RE: Inland Wetlands Commission Application
Project Site: 131 Danbury Road
Contract Purchaser: 131 Danbury Wilton Dev AMS LLC
(an affiliate of AMS Acquisitions, LLC)

SLR Project No.: 21543.00001

**RE: Wilton Inland Wetlands and Watercourses Agency Review
Application for a Significant Regulated Activity
Application #2904(S) ASML Acquisitions, LLC
131 Danbury Road, Wilton, Connecticut**

VH-2

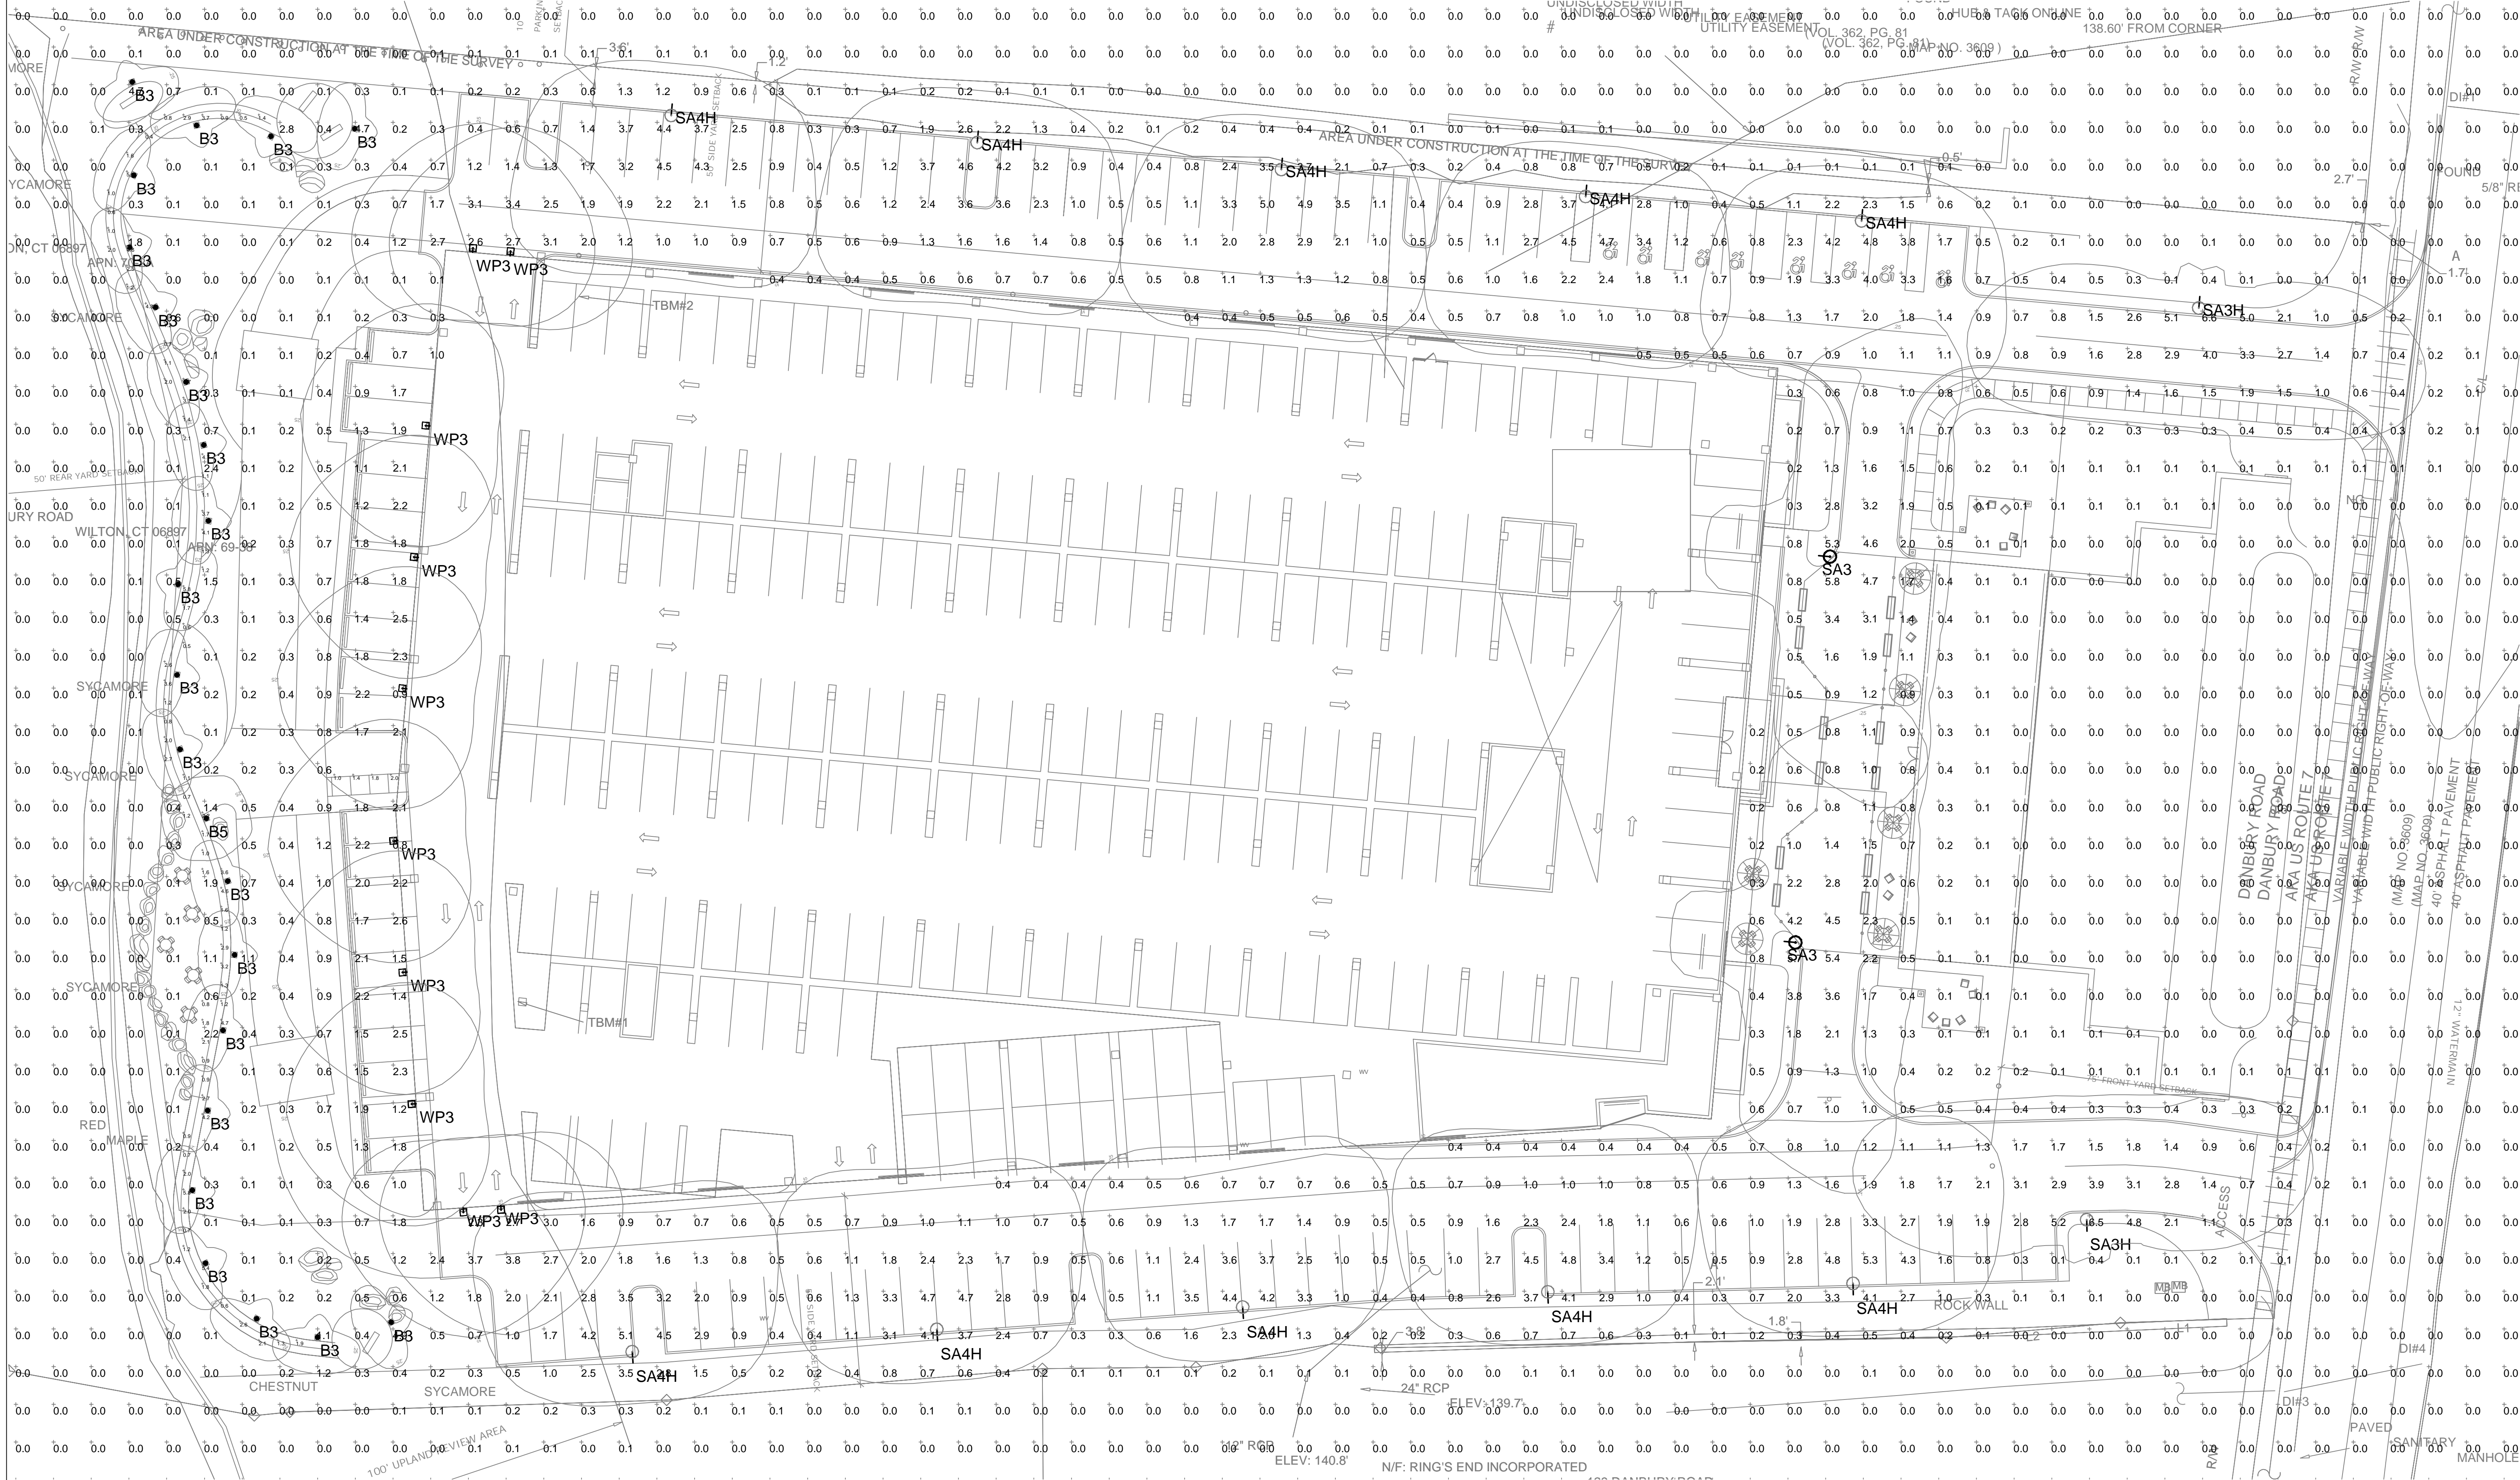
- C. LA-23: Appears inadequate space available at the southern of 2 truck spaces for turning in and out of space.
- R. LA-23: Turning movements for truck spaces have been provided on Sheet VH-2.**
